# UNITED STATES PATENT AND TRADEMARK OFFICE

09/532,786

Nobuhiko Hayashi

## **DETAILED ACTION**

FIG. 4

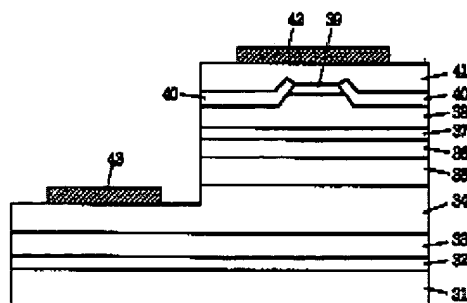
Figure 4 illustrates a nitride semiconductor laser having a nitride based semiconductor layer (32) with the composition of AlGaN, a nitride semiconductor layer (38) with the composition of AlGaN and formed into a ridge and the ridge having a width, a current blocking layer (40) formed on the side of the ridge to the top surface of the ridge, where the current blocking layers form a space on the top surface of the ridge, which has a width smaller than the width of the top surface of the ridge and a nitride semiconductor layer (39) with the composition of GaN is disposed in the space formed by the current blocking layers. See column 10 lines 15-37. Column 10 lines 42-44, discloses manufacturing the semiconductor laser by chemical vapor deposition such as (MOCVD), which is considered a transverse growth technique or process.

The current blocking layer of Kunisato et al illustrated in figure 4 has the composition of GaN or AlGa<sub>N</sub>, as described in column 10 lines 30-31.

Figure 4 illustrates an n-type cladding layer (35), an active layer (36) and a p-type cladding layer (38) having a ridge. See column 10 lines 15-30 and lines 42-53.

The current blocking layer of Kunisato et al illustrated in figure 4 has the composition of GaN or AlGa<sub>N</sub>, as described in column 10 lines 30-31.

Figure 4 illustrates the current blocking layer (40) having a single-layer structure.

The current blocking layer of Kunisato et al illustrated in figure 4 has the composition of GaN or AlGa<sub>N</sub>, as described in column 10 lines 30-31.

Kunisato et al discloses forming the current blocking layers (40) on the side of the ridge (38).

Kunisato et al discloses a nitride semiconductor cap layer (39), where the cap layer is inside the opening formed on the top surface of the ridge and a nitride semiconductor contact layer (41), which is in contact with the cap layer, and where both layers have the composition of p-type GaN and provide an electrical contact between the electrode (42) and the ridge.

Kunisato et al does illustrate in figure 4 an electrode (42), as described in column 10 lines 38-40.

Figure 4 Kunisato et al illustrates the current blocking layer (40) having a single-layer structure with the composition of GaN or AlGaN, as described in column 10 lines 30-31.
